RECEIPT DATE: 7/1/15 **ONSITE SEWAGE DISPOSAL SYSTEM** P 556508
 APPROVAL DATE: 9/2/15 SEC **PERMIT: CONSTRUCTION** A _____

PROPERTY ADDRESS: 13112 Greenberry Lane
 SUBDIVISION: Greenberry LOT: 2 TAX ID: _____
 CONTRACTOR: South Carroll Backhoe EMAIL: scbackhoe@comcast.net
 CONTRACTOR ADDRESS: 4410 Salem Bottom Road, Westminster, MD 21157 PHONE: 410-596-3618

RE: Greenberry Tenant House
13110 Greenberry Lane
Building Permit B14004173

GREENBERRY TENANT HOUSE
13112 GREENBERRY LANE, CLARKSVILLE, MD
TAX MAP 28, PARCEL 48
FIFTH ELECTION DISTRICT
HOWARD COUNTY, MARYLAND
SITE PLAN FOR BAT INSTALLATION

GREENBERRY TENANT HOUSE
13110 GREENBERRY LANE, CLARKSVILLE, MD
TAX MAP 28, PARCEL 48
FIFTH ELECTION DISTRICT
HOWARD COUNTY, MARYLAND
SITE PLAN FOR BAT INSTALLATION

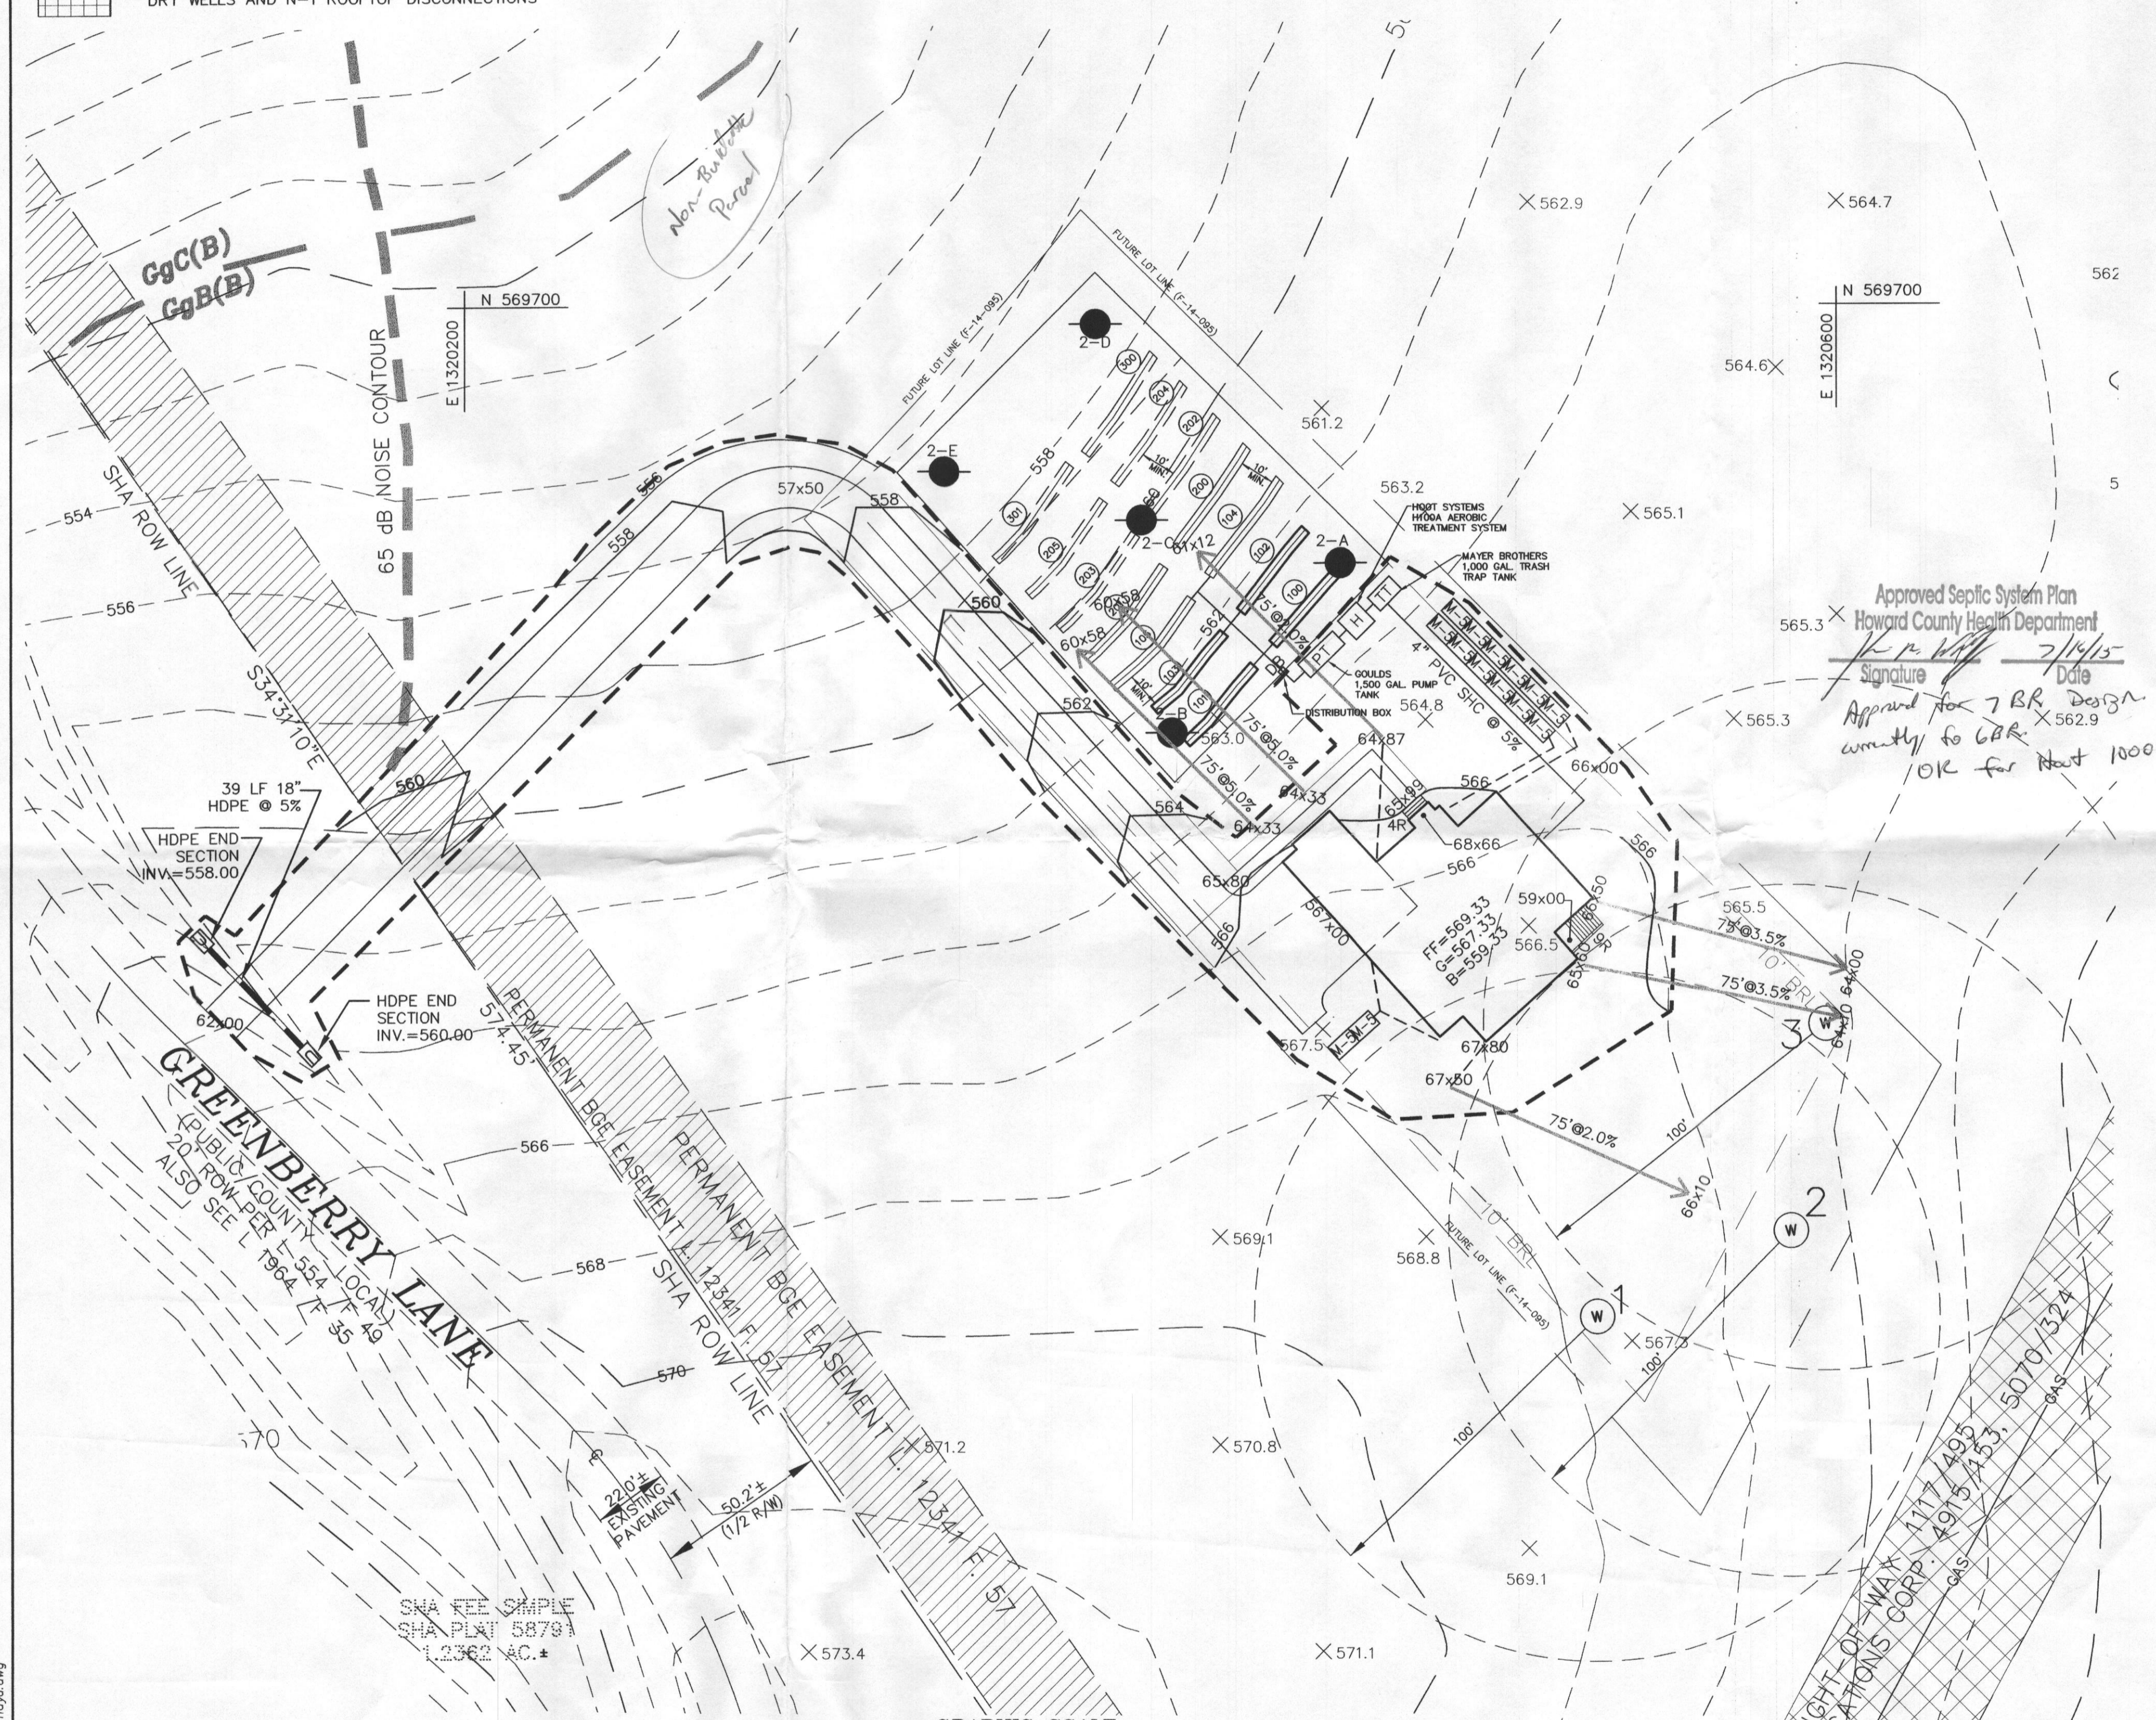
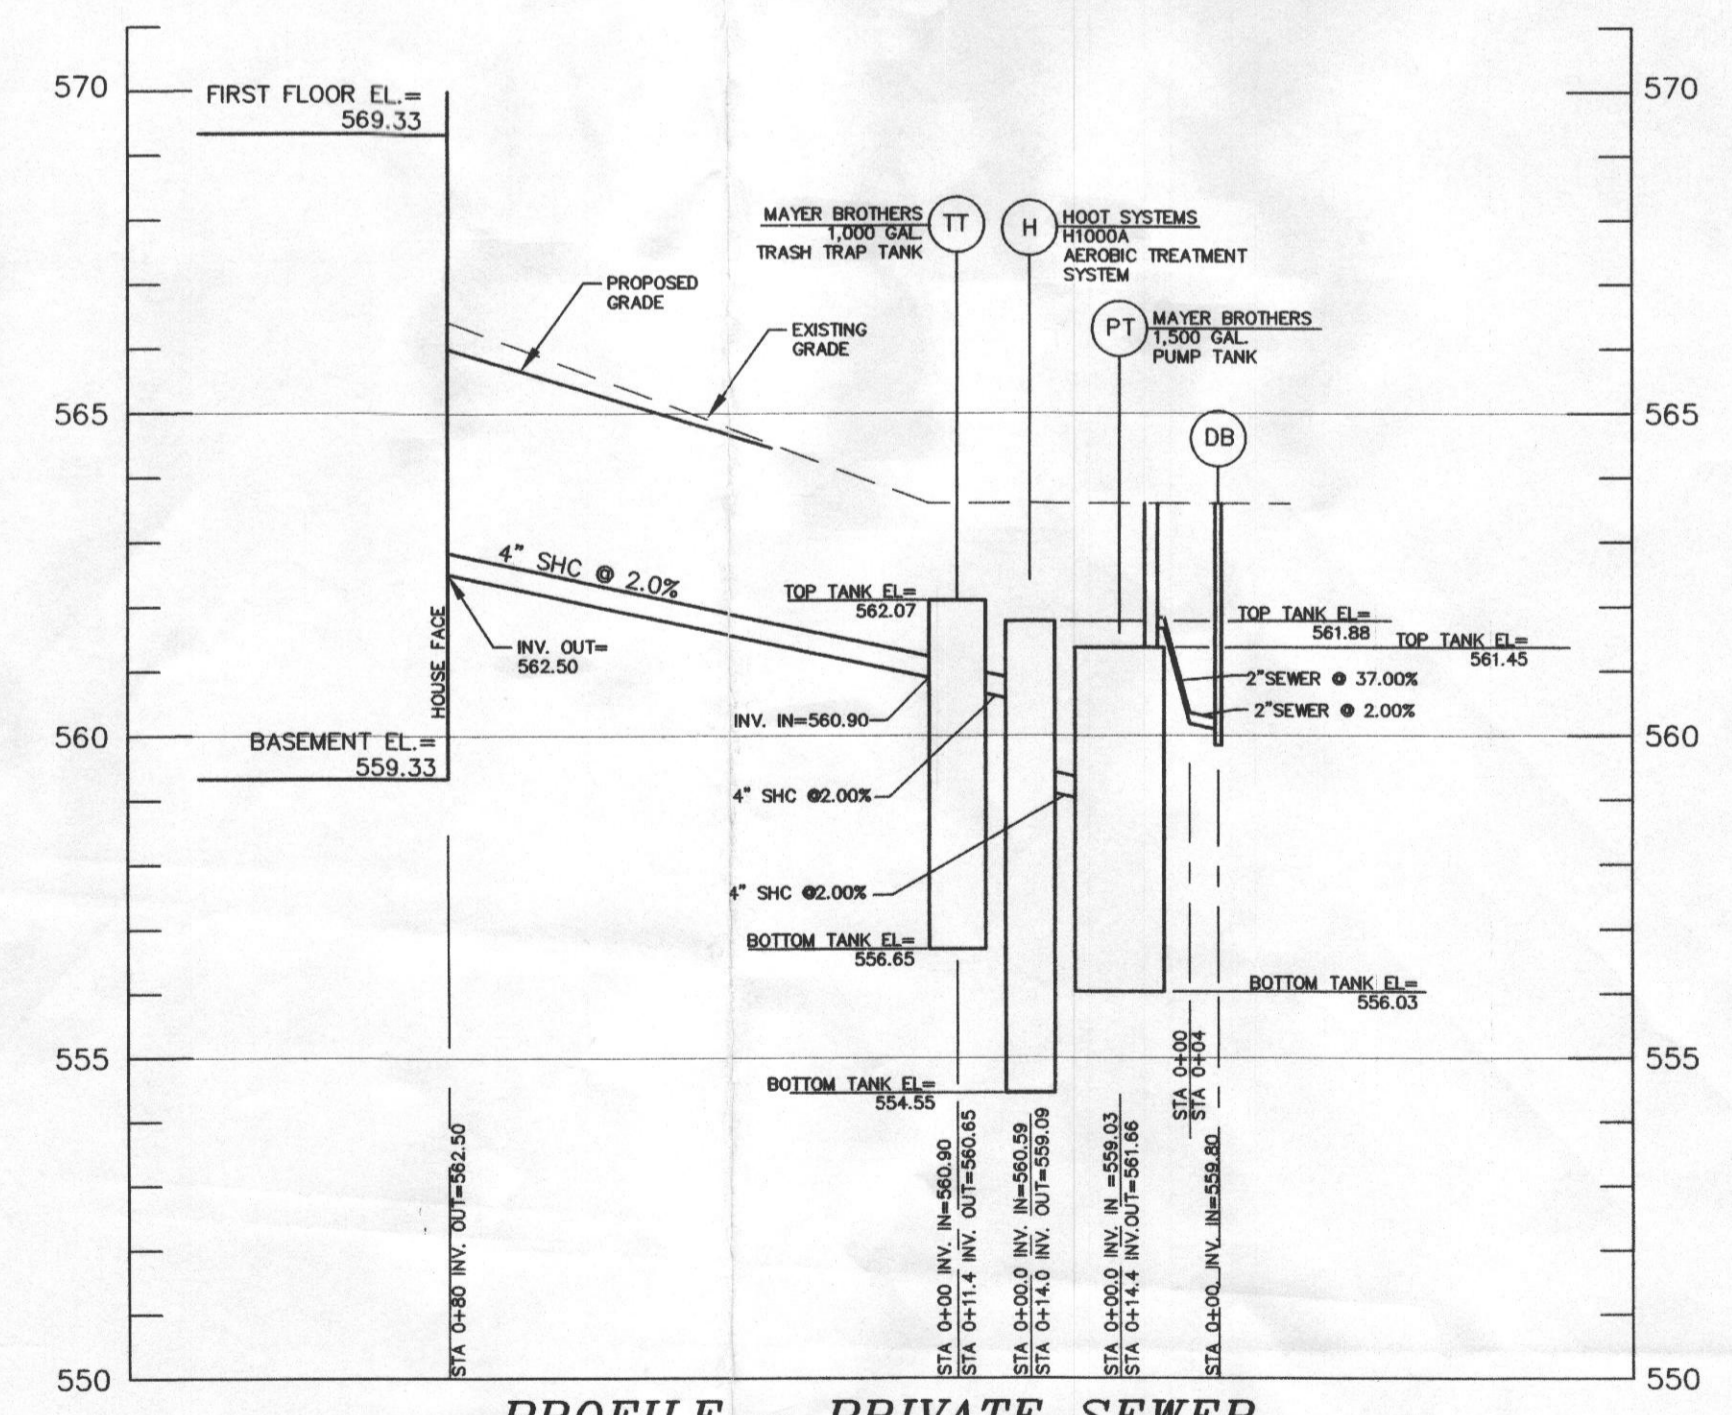
Handwritten note: Not including c. 30' 3' wide is depth. Trench

Handwritten note: 3.5'-8' 3' wide

Handwritten calculation: $\frac{1050}{1.2} = 875 \div 2 = 437.5 (3.5) = 149.17$
291

Approved Septic System Plan
Howard County Health Department
Signature: [Signature]
Date: 7/19/15
Approved for 7 BR design
warranty to GBR
OK for Hoot 1000a
